Unit Injector Yoke Hold-Down Bolt Torque Specification CHU, CXU, GR, GU, PI

FSB 237-020, Unit Injector Yoke Hold-Down Bolt Torque Specification

(September 2017)

Unit Injector Yoke Hold-Down Bolt Torque Procedure

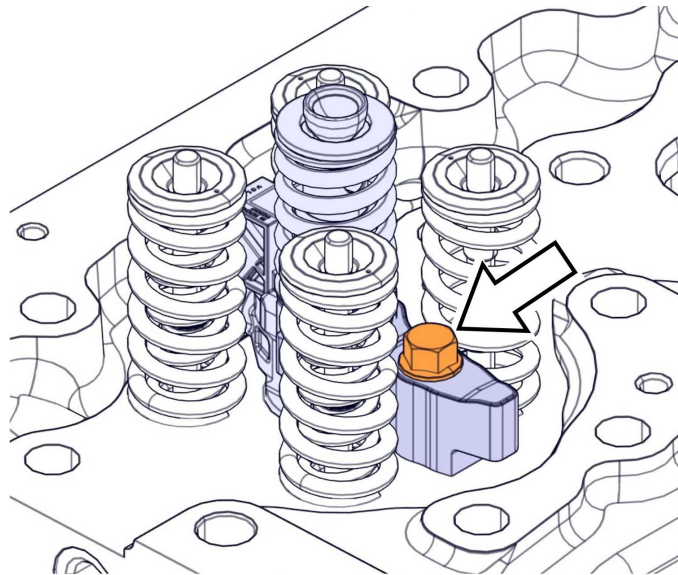
MACK CHU, CXU, GR, GU, and PI trucks built from 2009 to 2017 and equipped with MP7, MP8, and MP10 engines (EM-USA10, EM-USA14, and EM-USA17), will require a new torque specification for the Unit Injector Yoke Hold-Down Bolt. Effective immediately, the torque value in step 4 has changed to 25 +5/-0 Nm (18 +4/-0 ft-lb). See the torque procedure in steps 1 through 5 below. Additionally, the new yoke hold-down bolt torque will be updated in all service procedures, methods, and specification manuals.

Note: If the unit injector yoke hold-down bolts are removed, do not reuse. The unit injector yoke hold-down bolts are made for one time use only.

- 1 Tighten 20 +5 Nm (15 +4 ft-lb).
- 2 Tighten 180 ±5 degrees.
- 3 Loosen the bolt until the torque is 10 to 15 Nm (7 to 11 ft-lb), back off approximately 150 Degrees.
- 4 Tighten 25 +5/-0 Nm (18 +4/-0 ft-lb).
- 5 Tighten 90 ±5 degrees.
